STATE OF NORTH CAROLINA  
DEPARTMENT OF TRANSPORTATION

Subject: **Response to US Army Corps of Engineers Letter** for the proposed NC 133 Connector from NC 211-133 (Southport Supply Road) to NC 87-133 (River Road), Brunswick County, TIP R-3324.

References: Application for an Individual Section 401 Water Quality Certification dated July 19, 2012  
USACE Request for Additional Information Letter dated, September 18, 2012 (received September 24, 2012).  
NCDOT Response to US Army Corps of Engineers Letter dated, October 18, 2012.

# SITE I

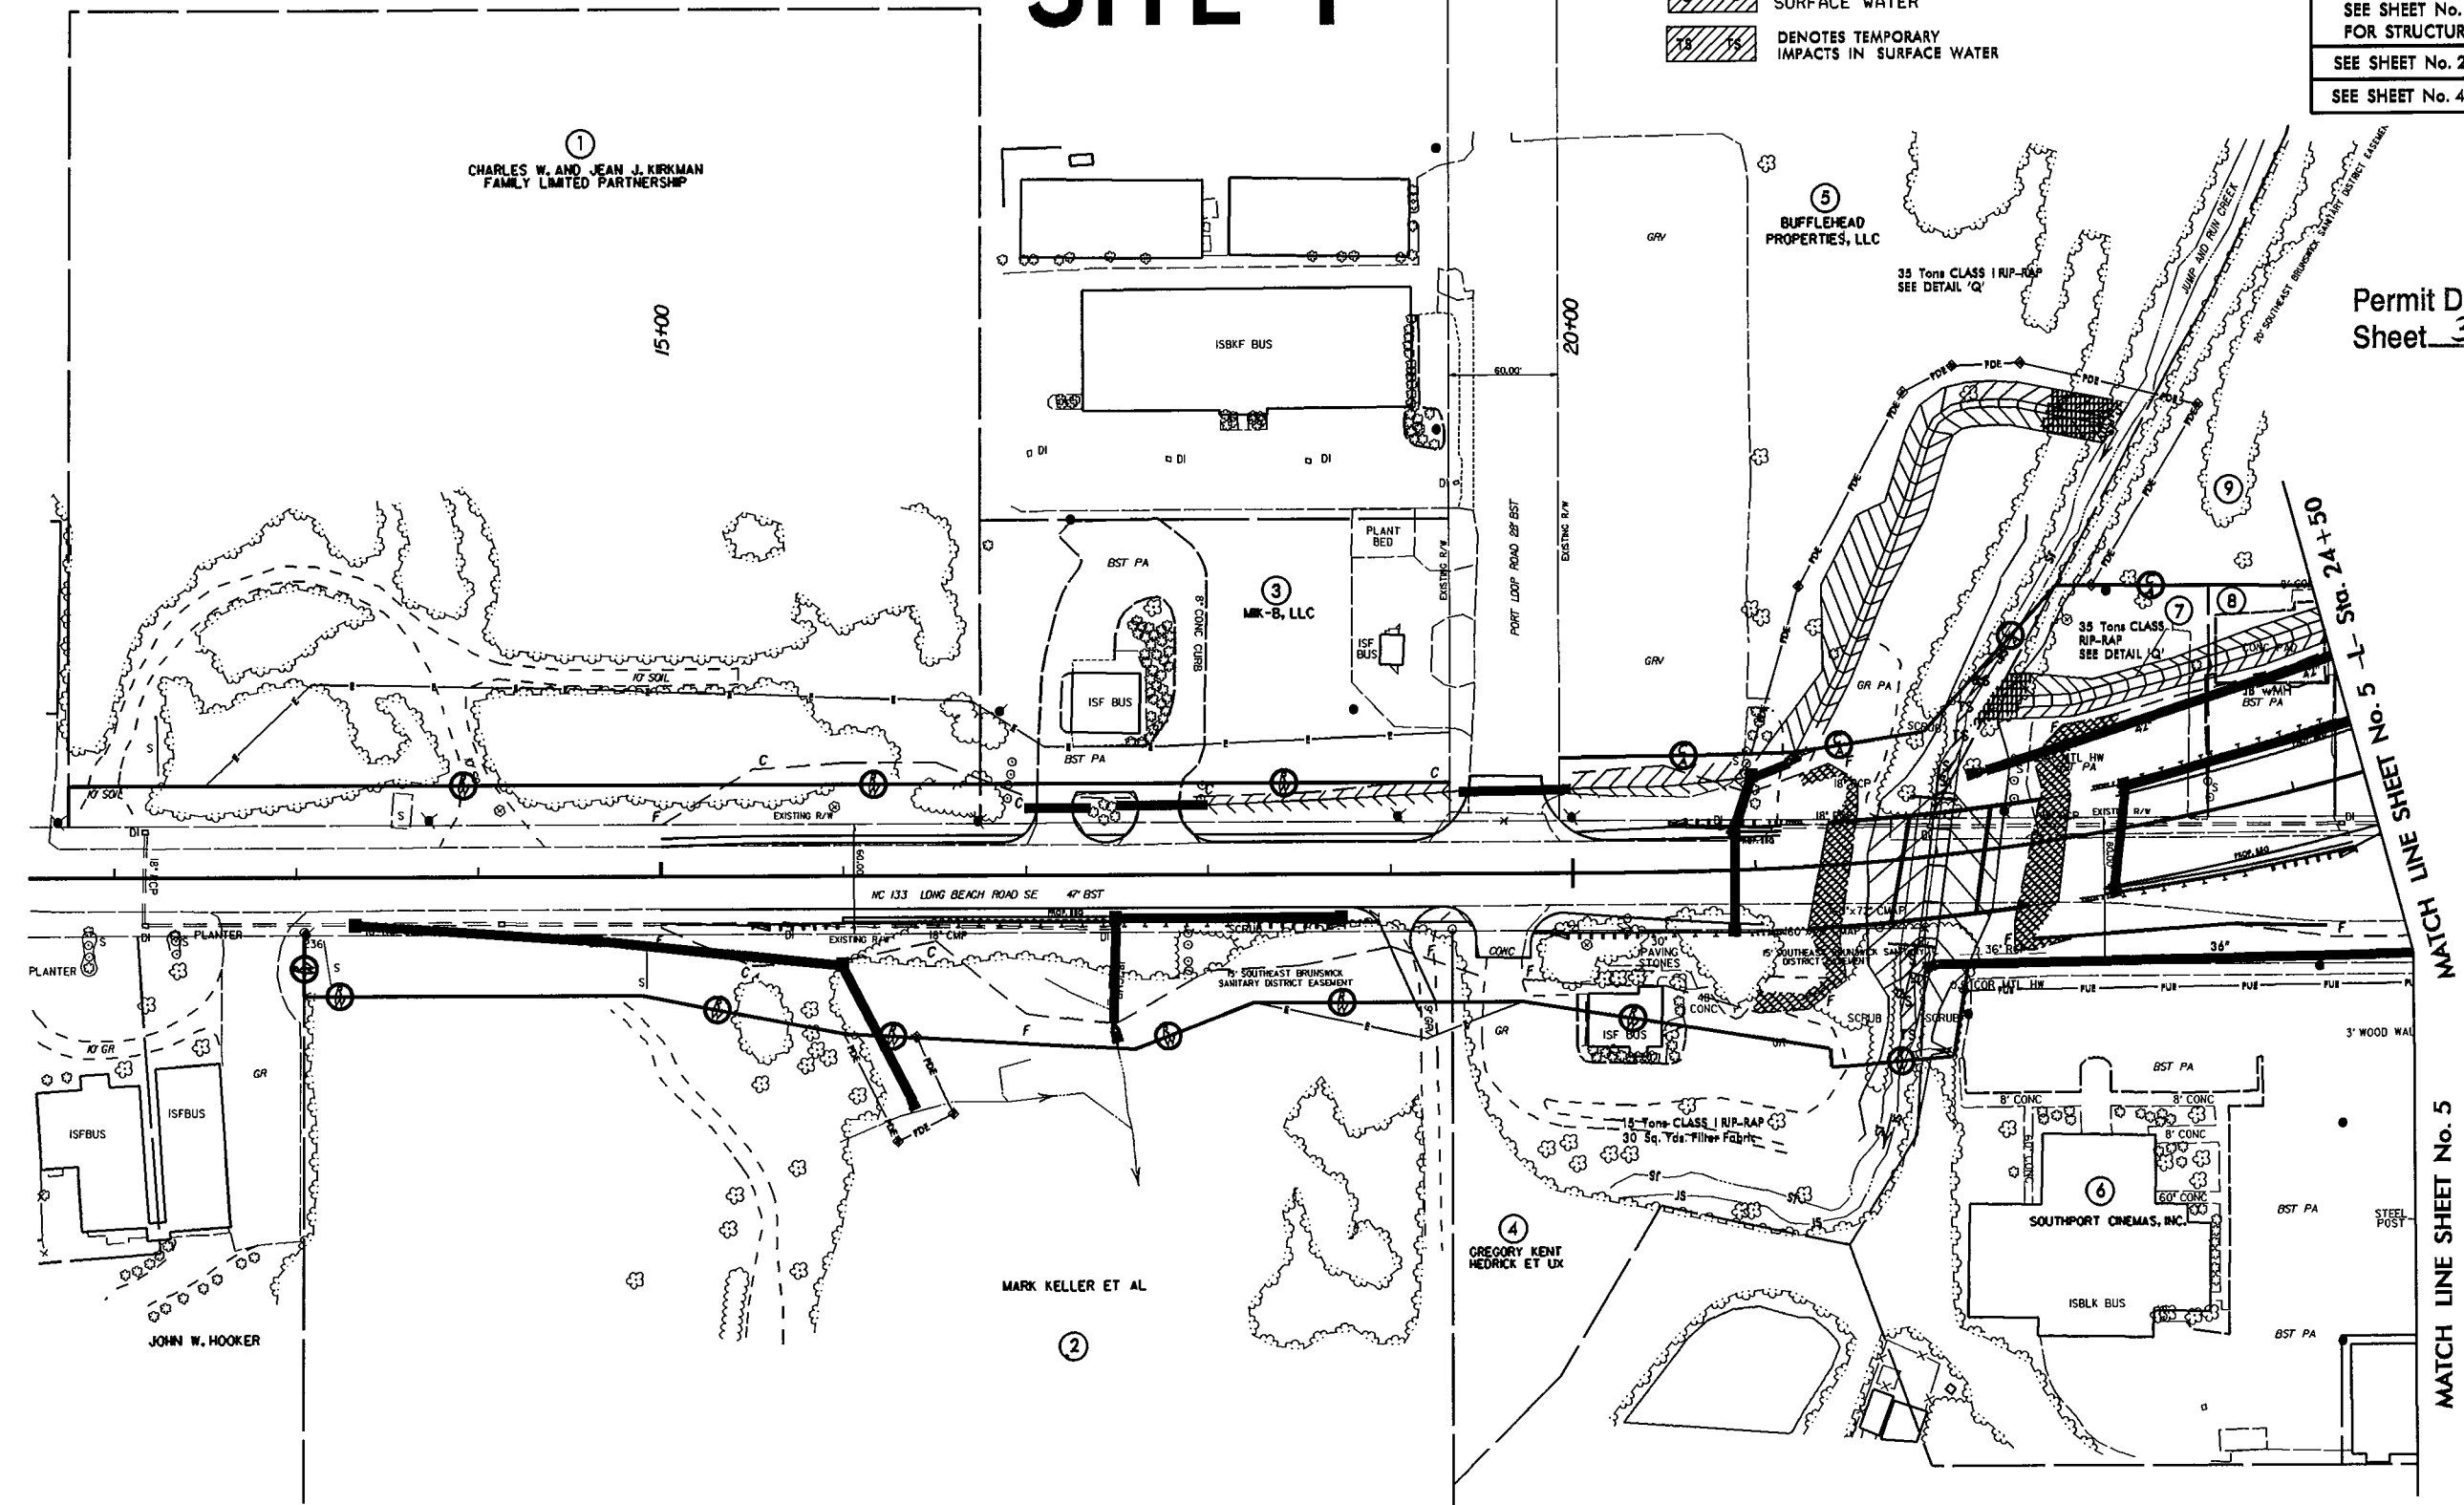
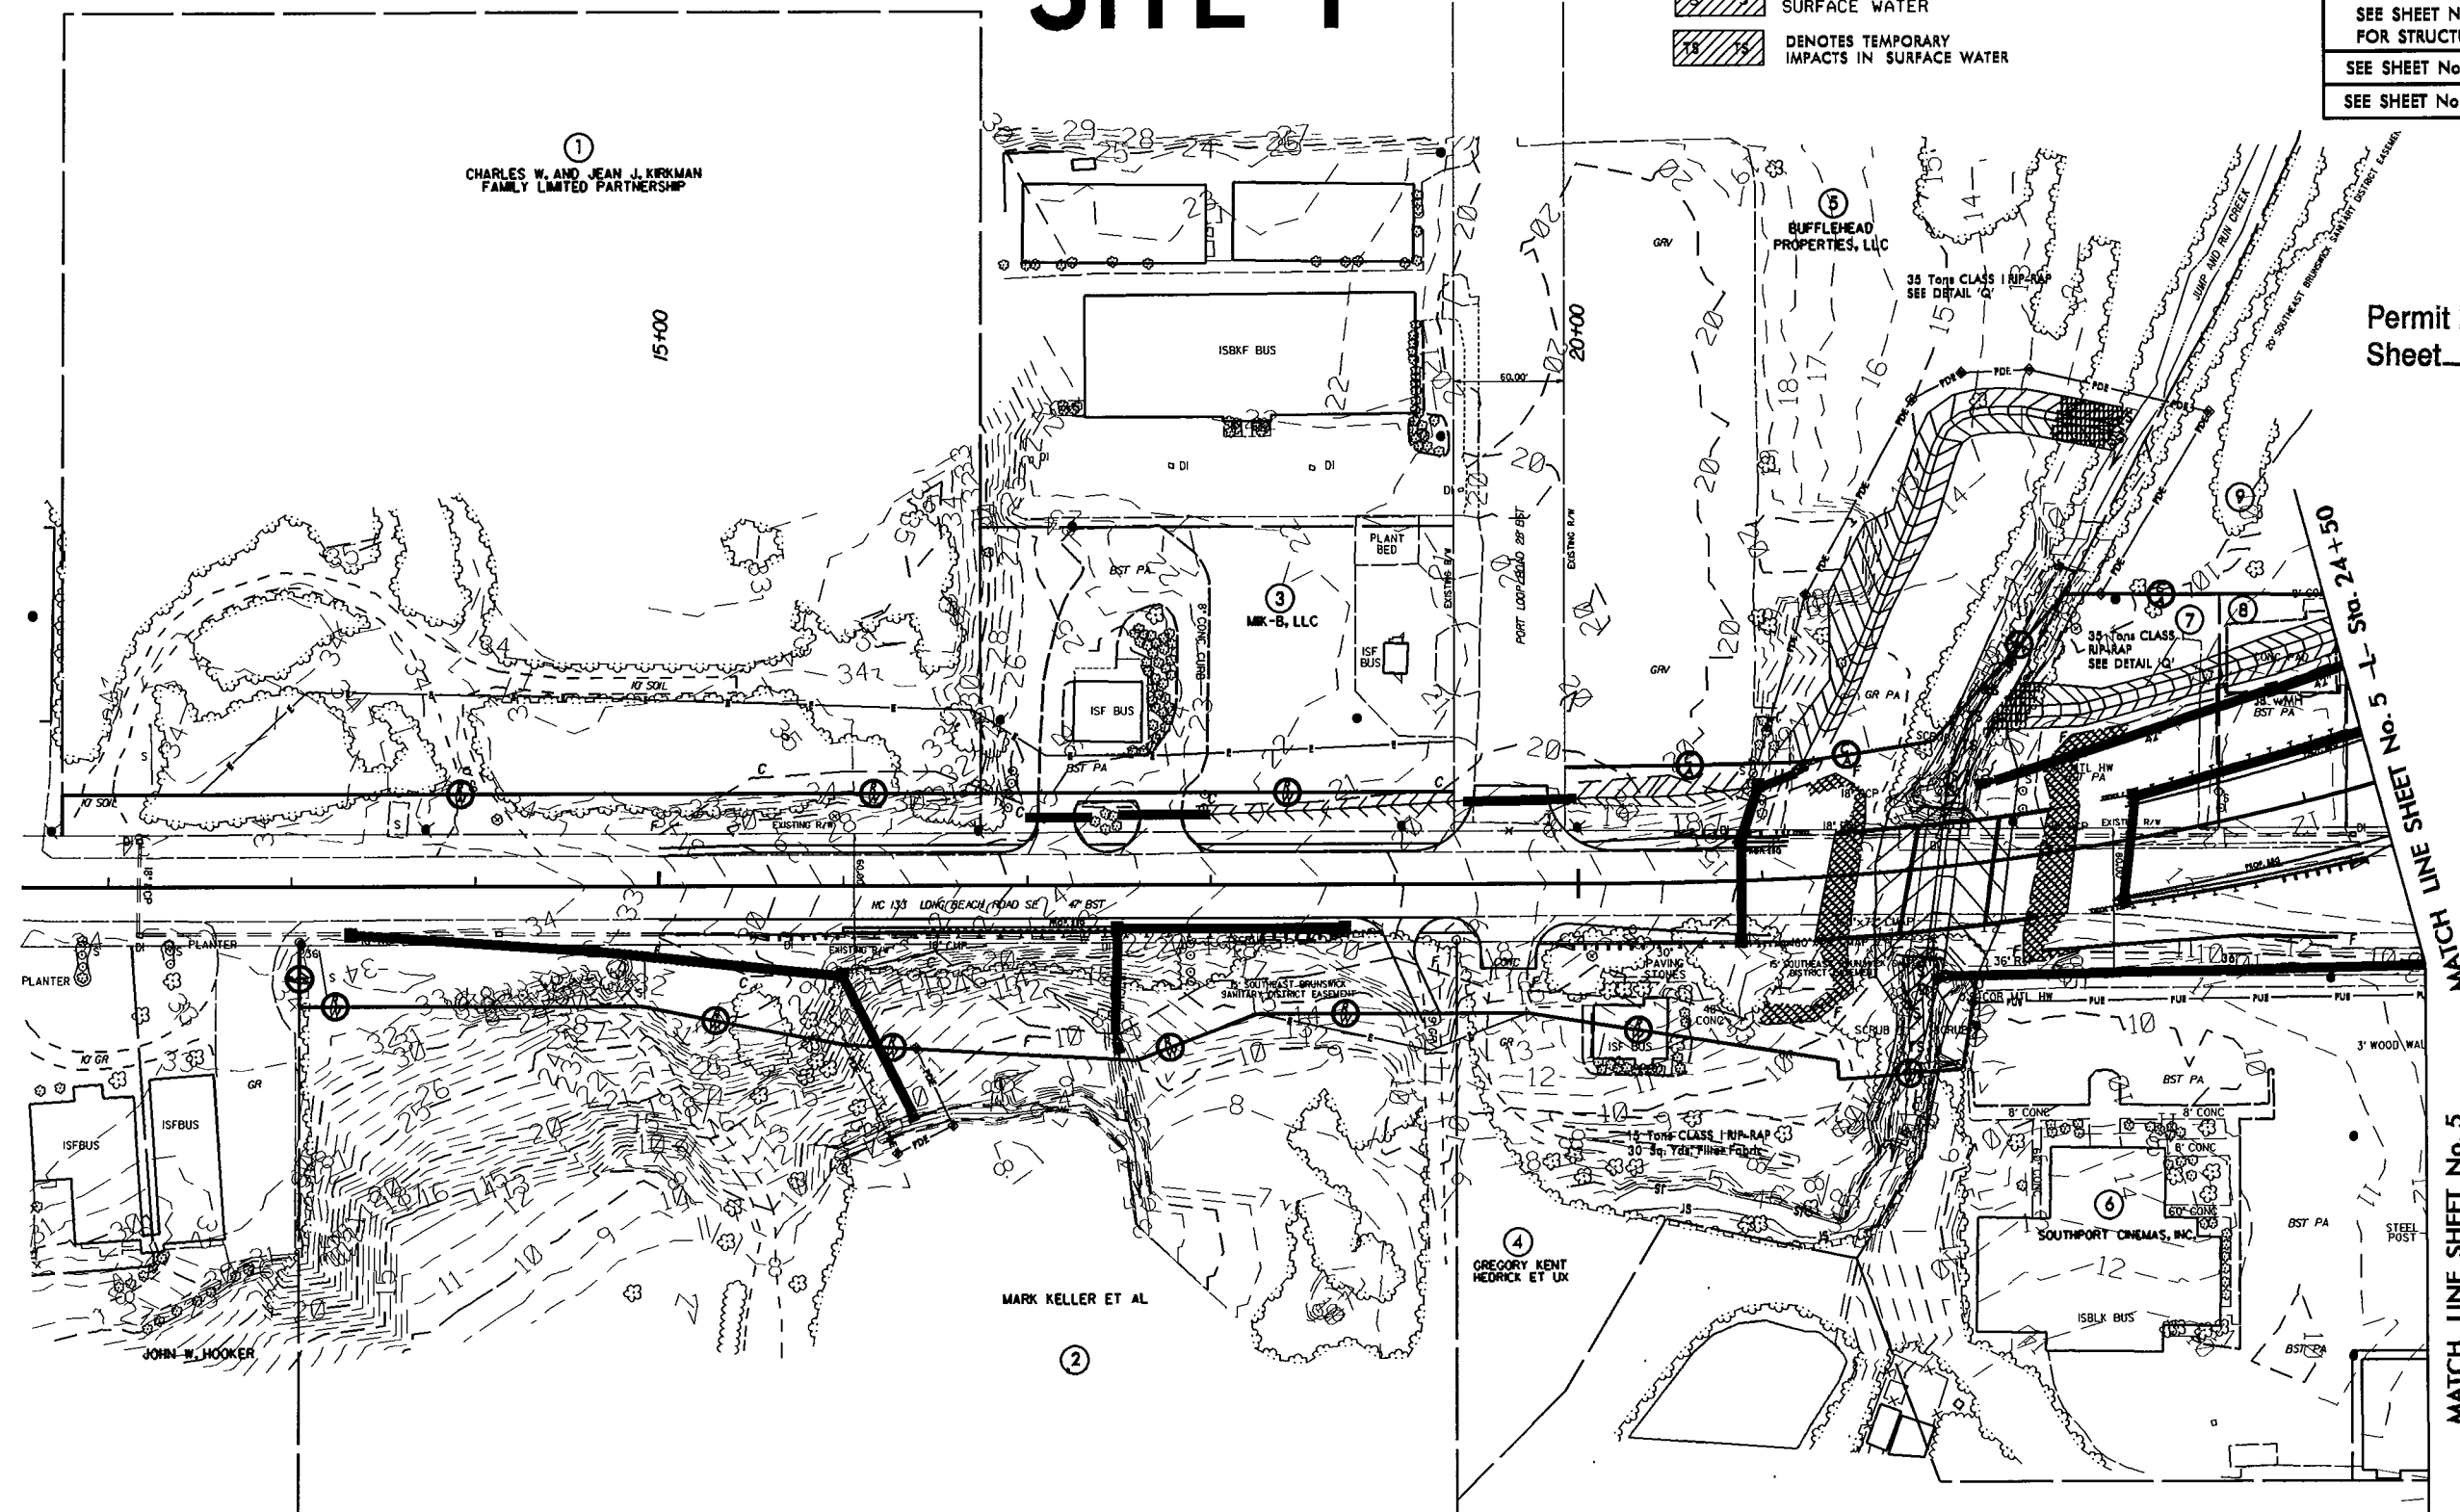
2. *Site 1: Removal of existing culverts will benefit stream and should be footnoted as culvert removal and not stream fill.*

Impact calculations were revised to remove the impacts from the stream relocation.
